# **TOWN OF BRISTOL, RHODE ISLAND**

**C1. (Continued) Public Hearing and Master Plan Phase review and possible action on same for Major Land Development** for proposal to construct a new Mt. Hope High School, including new tennis courts and athletic fields, at **199 Chestnut Street** and to demolish the existing high school building. Owner: Town of Bristol / Applicant: Bristol Warren Regional School District/Lisa Pecora, Perkins Eastman, applicant representative. Zoned: Public Institutional. Assessor's Plat 117 Lots 3-7.

### DRAFT PLANNING BOARD DECISION

Re: **Master Plan – Supplemental Information**  
**Mt. Hope High School**  
**199 Chestnut Street**  
**Bristol, RI**  
 (Pare Project No. 23099.01)

DRAWING NO.:  
C3.0  
SHEET NO. 5 OF 10

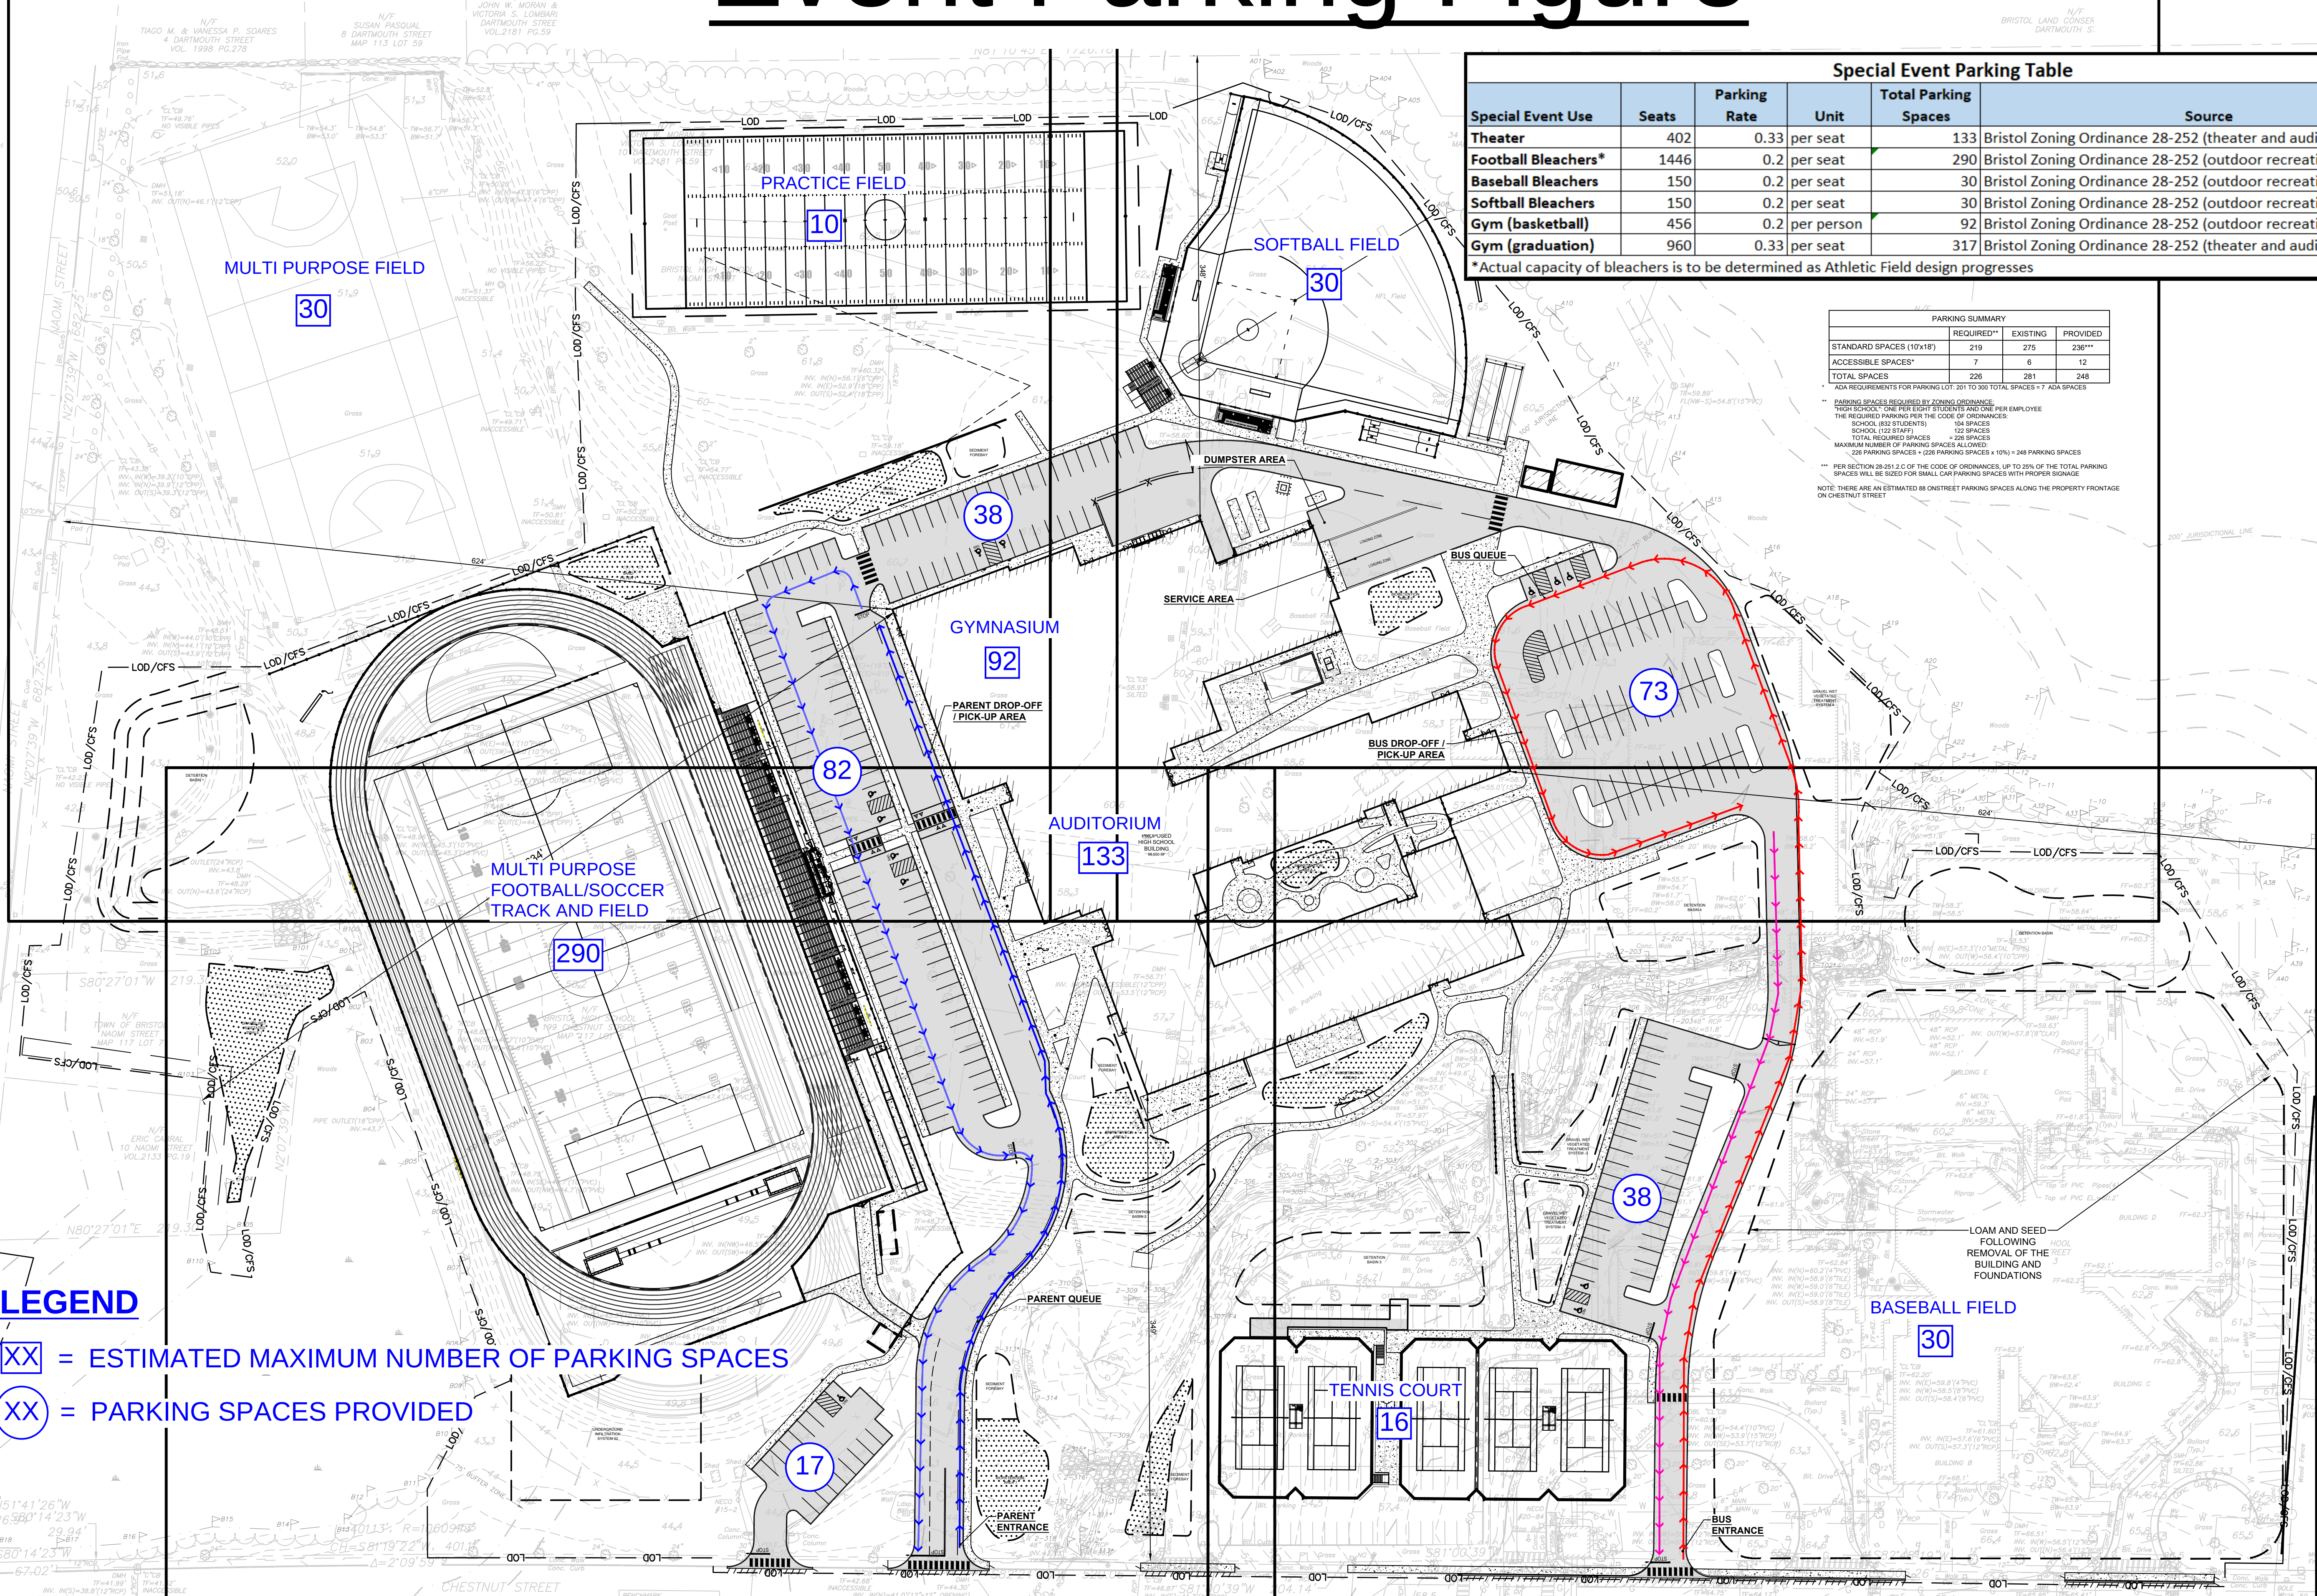
In response to concerns regarding the proposed 240 off-street parking spaces, the revised Master Plan Sheet C3.0 proposes 248 parking spaces. The existing high school has 281 parking spaces. BWRSD has determined that 248 parking spaces satisfies the future high school needs for the school day by providing parking spaces for the 122 staff members, 10 visitors and 116 students who are permitted to park on site. BWRSD anticipates the Master Plan will provide adequate parking spaces for the high school's operations and special events. Supplemental information to support the number of proposed parking spaces is included below:

- Attachment 2, presented in the Planning Board meeting on September 12, 2024, depicts the off-street parking available for the variety of anticipated athletic and cultural events.

DRAWING NO.:  
**C3.0**  
SHEET NO. 5 OF 10

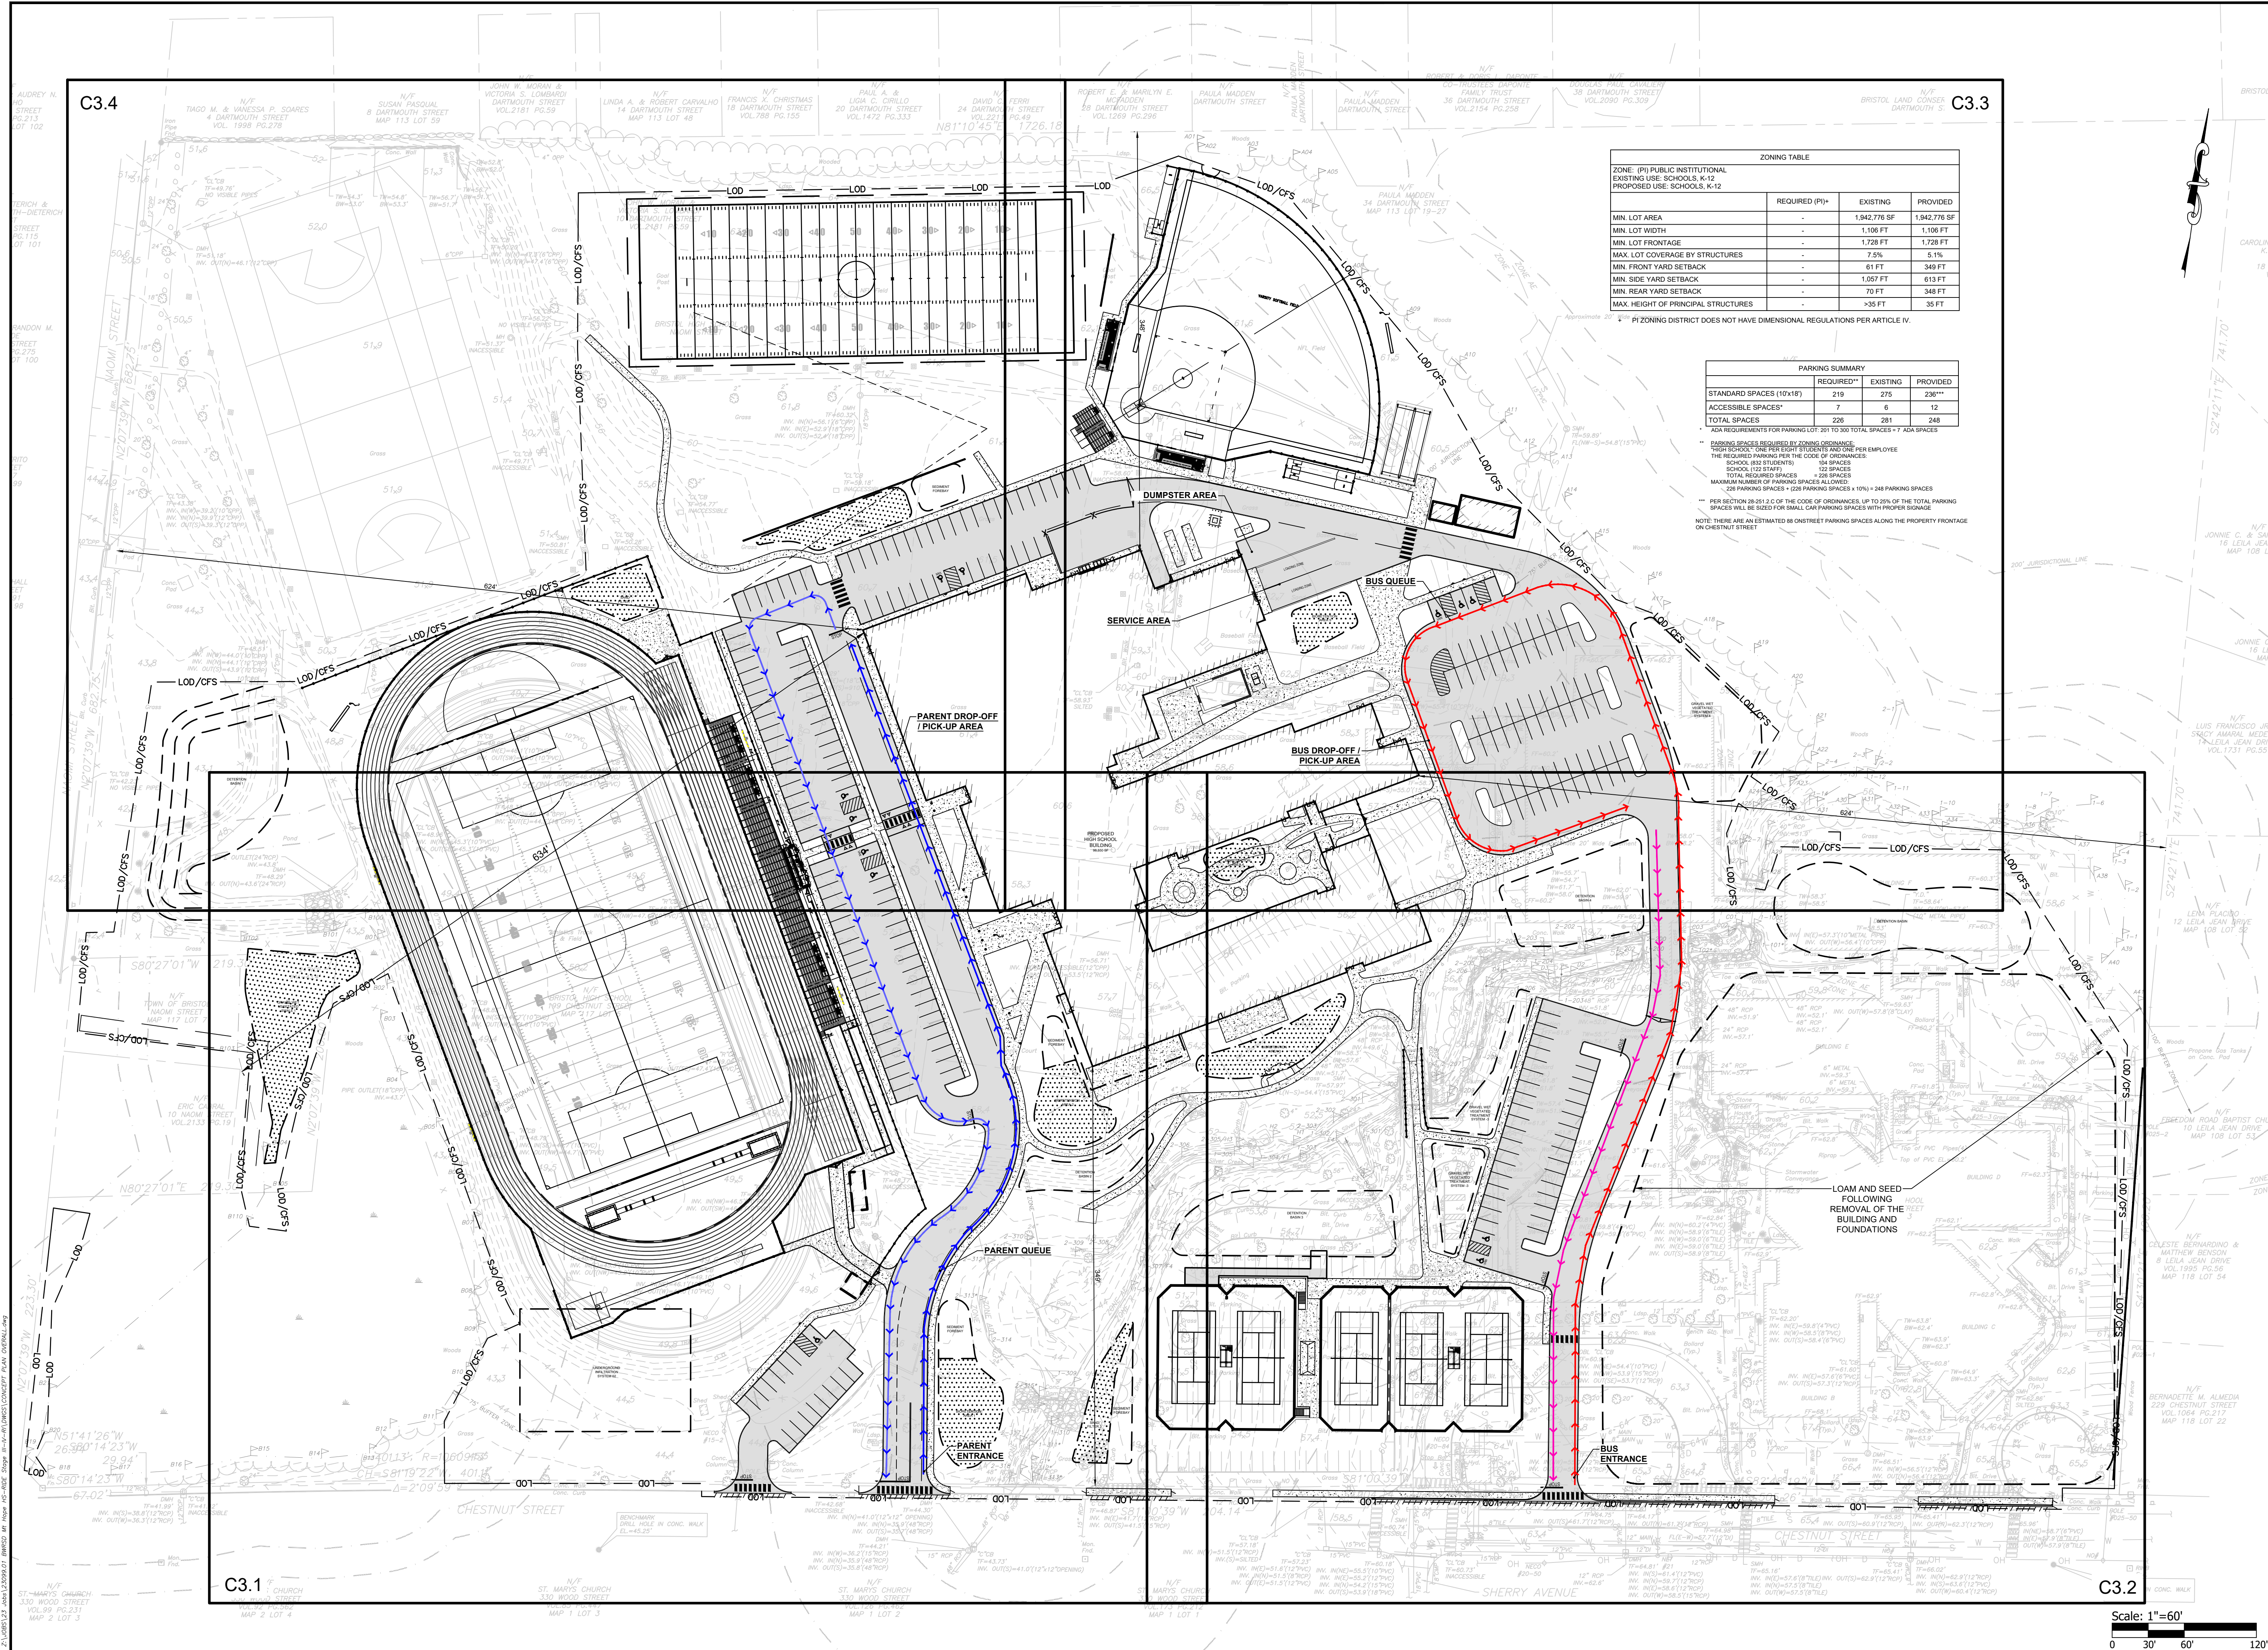
The Master Plan is revised depicting a large underground infiltration system comprised of chambers, pipe, and crushed stone that will store and slowly infiltrate stormwater into the underlying soils. The underground infiltration system, combined with infiltration in other BMP’s, will result in no increase to runoff volume in the 10-year design storm.

The Design Team revised the Master Plan with reduced impervious surfaces to help mitigate concerns regarding stormwater runoff. The reduction is achieved by reducing sidewalk widths, providing compact parking spaces where allowed by the Town of Bristol Code of Ordinances, and minimizing pavement where feasible.
